**Legislative Council
Panel on Home Affairs and Panel on Development
Joint Subcommittee to Monitor the Implementation of the
West Kowloon Cultural District Project**

Follow-up to meeting on 25 February 2013

**Home Affairs Bureau
West Kowloon Cultural District Authority
April 2013**

OVERALL BUILDING HEIGHT PROFILE

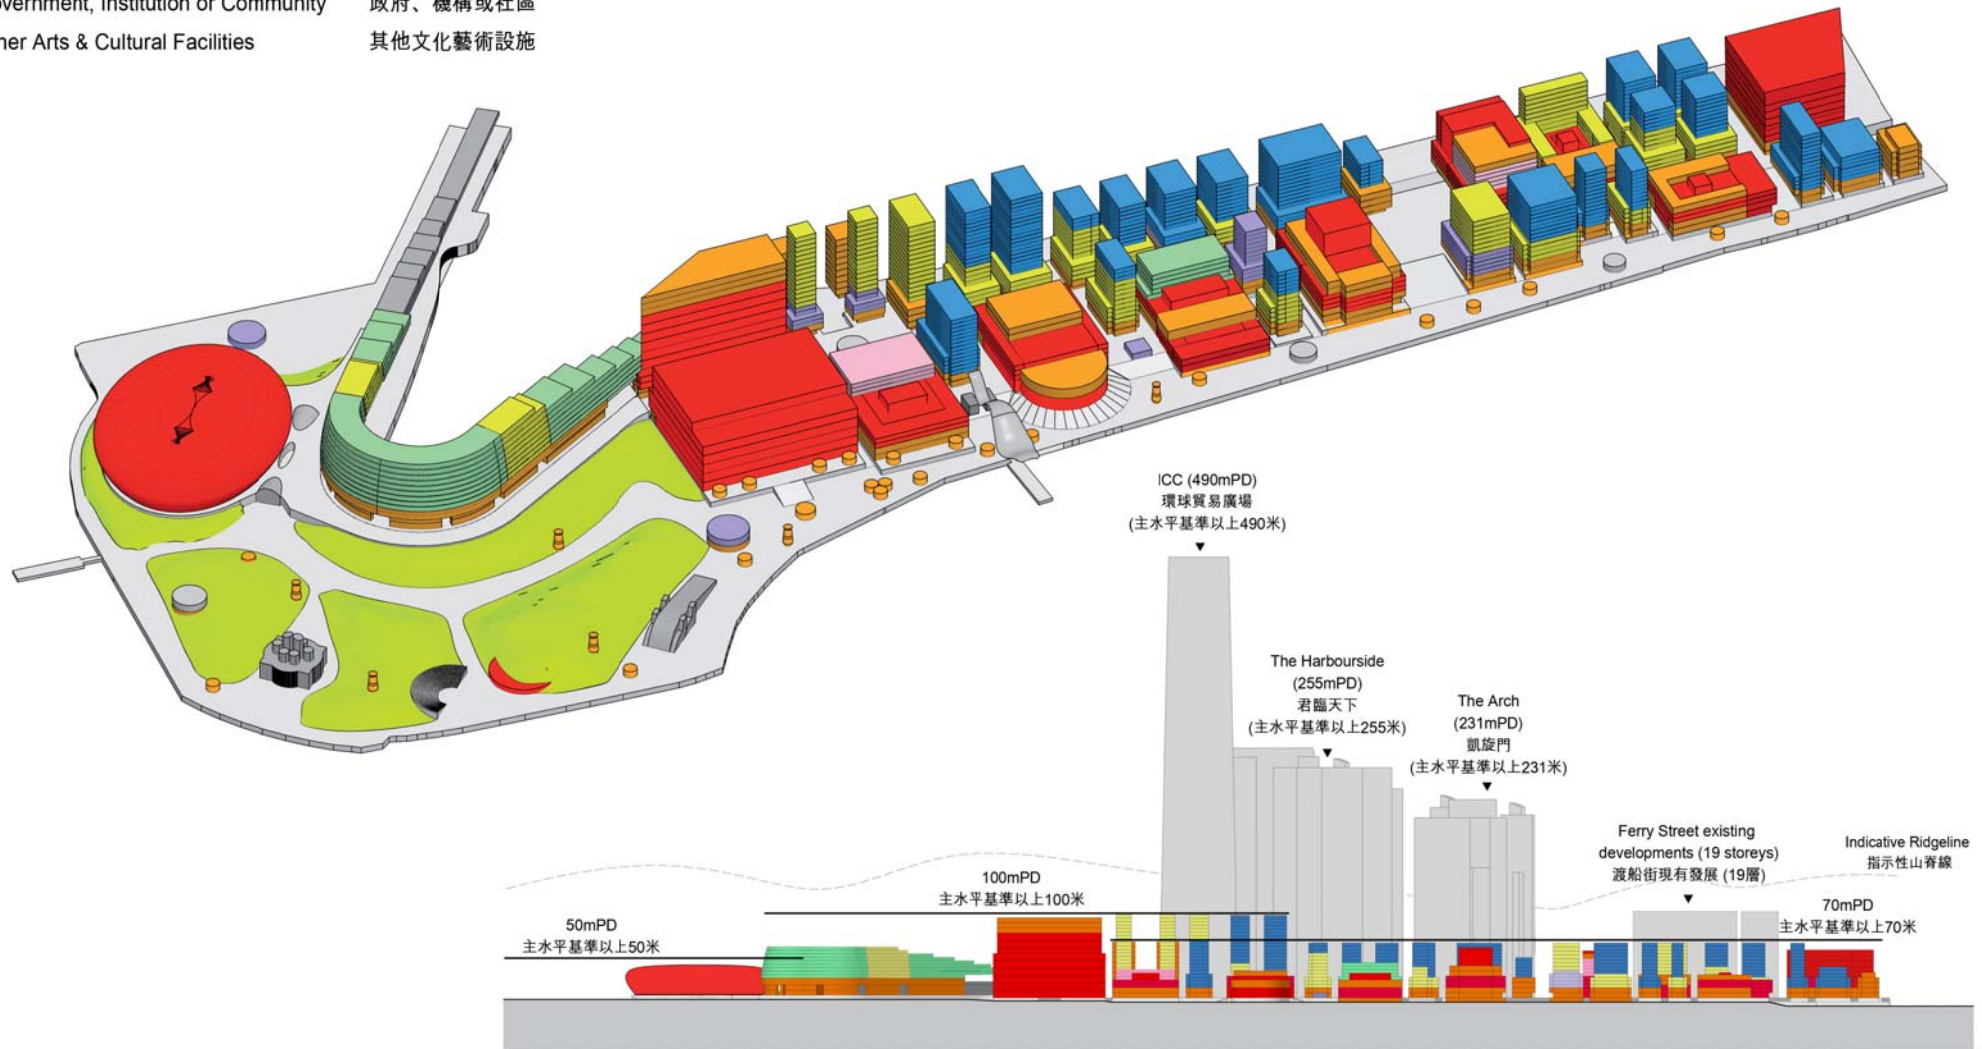
- (a) provide a three-dimensional plan showing the building height profile of future developments in WKCD;**

Please see attached the requested plan (**Annex 1**).

Annex 2
附件2

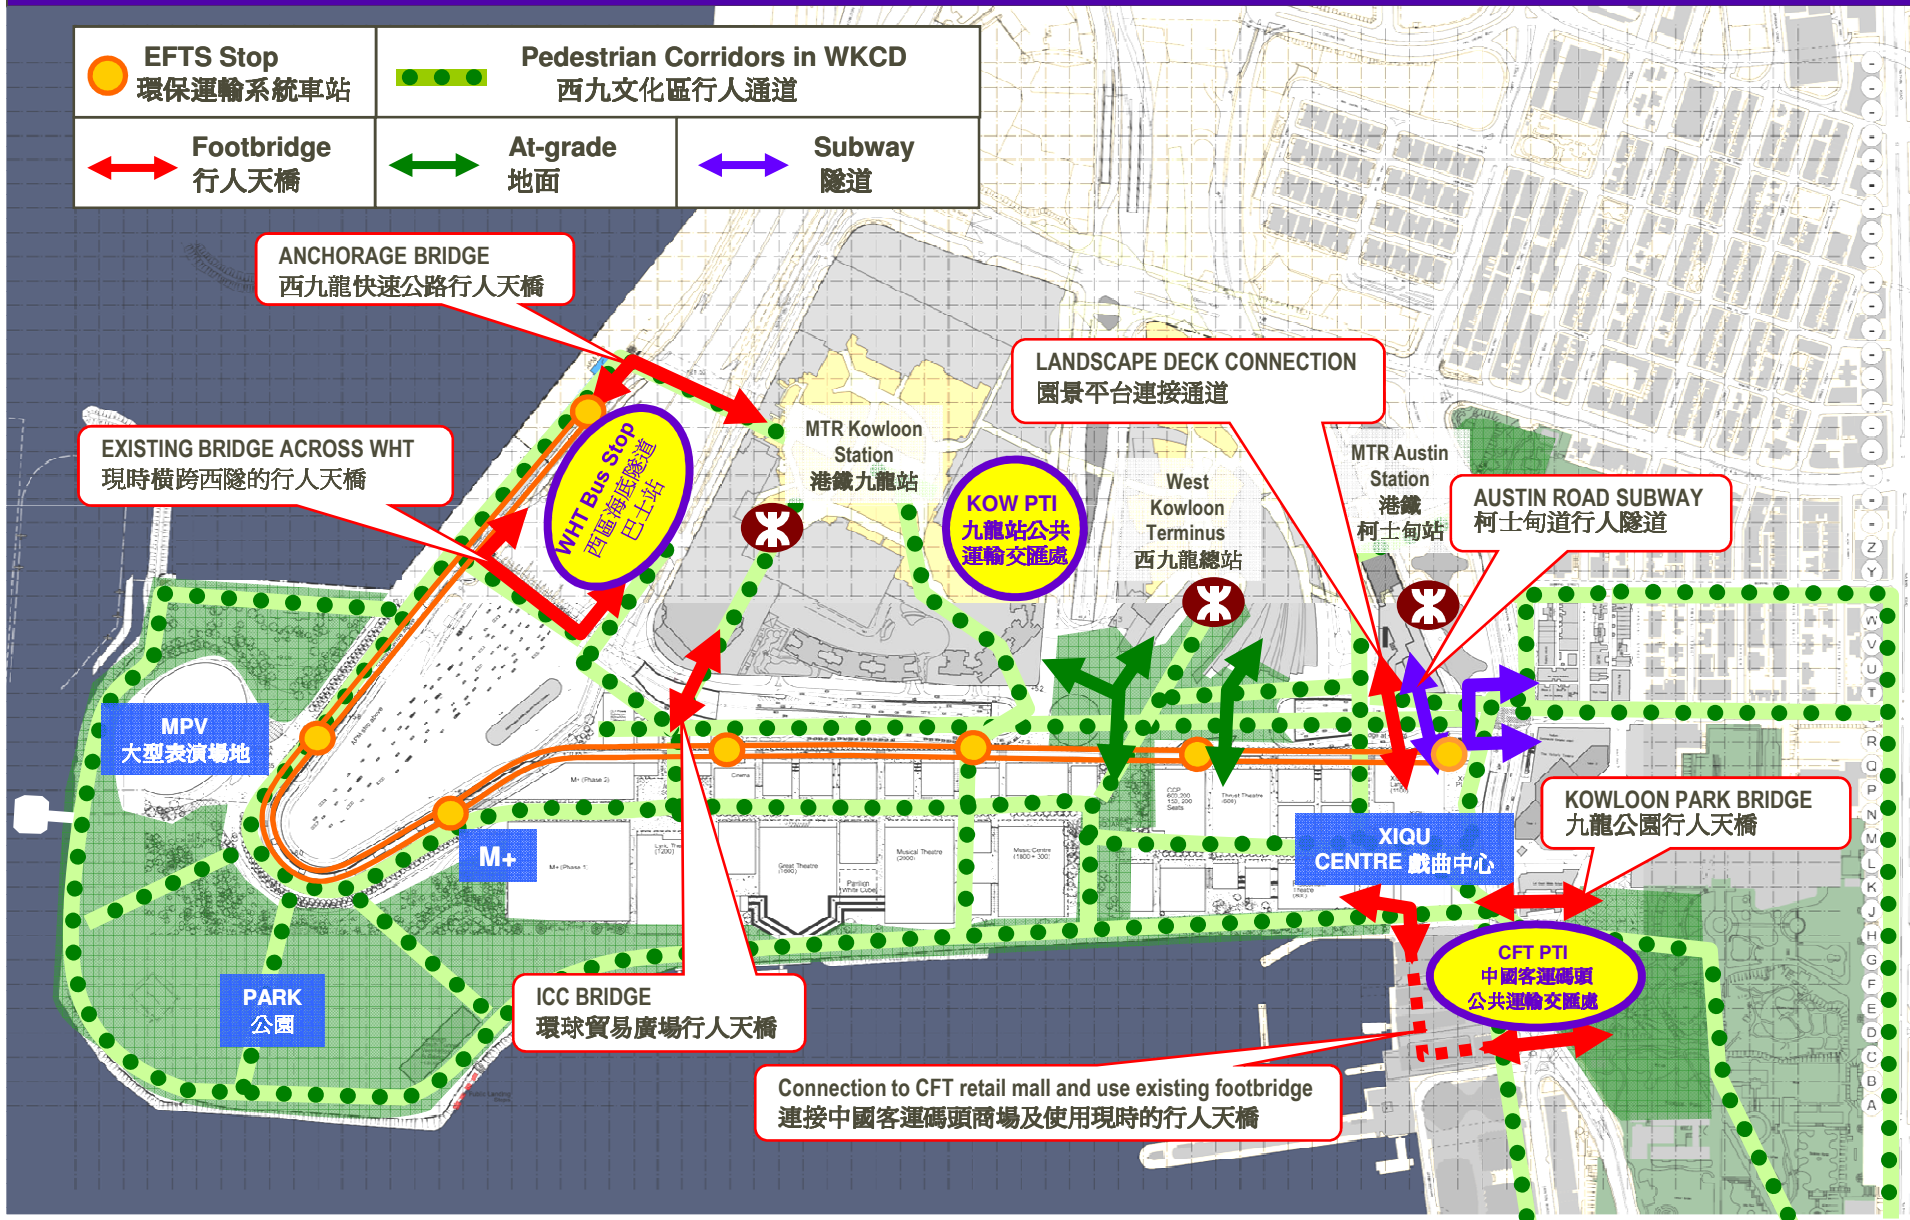
- (b) provide information on the measures/facilities to be put in place to enhance pedestrian accessibility to and within WKCD, as well as to improve the connectivity of WKCD with its neighbouring districts (in particular Yau Ma Tei and Jordan areas);**

Pedestrian connections to the areas outside WKCD are primarily through the provision of grade-separated pedestrian deck, footbridges and subways. **Annex 2** shows the pedestrian connections with the adjoining developments and major public transport nodes. These connections will be completed progressively to dovetail with the commissioning of various arts and cultural venues. The proposed footbridge/subway connections are briefly described as follows -

- (i) Kowloon Park Bridge and China Ferry Terminal Bridge – Upon relocation of the existing Tsim Sha Tsui Fire Station Complex and subject to future demand and investigation on feasibility, a footbridge can be provided over Canton Road to link WKCD and Kowloon Park to facilitate pedestrian access to the Tsim Sha Tsui (TST) district, including MTR TST Station. The footbridge will be phased with an initial connection to China Ferry Terminal and public transport interchange within the terminal.

- (ii) Extension of Existing Austin Road Subway – The existing Austin Road pedestrian subway which is already connected to MTR Austin Station will be extended and improved, to connect to the basement of Xiqu Centre.

- (iii) Landscape Deck Connection – Subject to demand and justifications, a pedestrian connection will be formed by utilising the planned landscape deck for noise mitigation over Austin Road West to link up WKCD and MTR Austin Station.

- (iv) The Elements West Connection (ICC Bridge) – This footbridge over Austin Road West will connect the Artist Square of WKCD and retail zone of the Elements shopping mall.

- (v) Kowloon Station Connection (Anchorage Bridge) – This footbridge will link the northern tip of WKCD and the concourse of MTR Kowloon Station. It provides direct connection to the Elements shopping mall and linkage to the check-in area of the Airport Express Line.
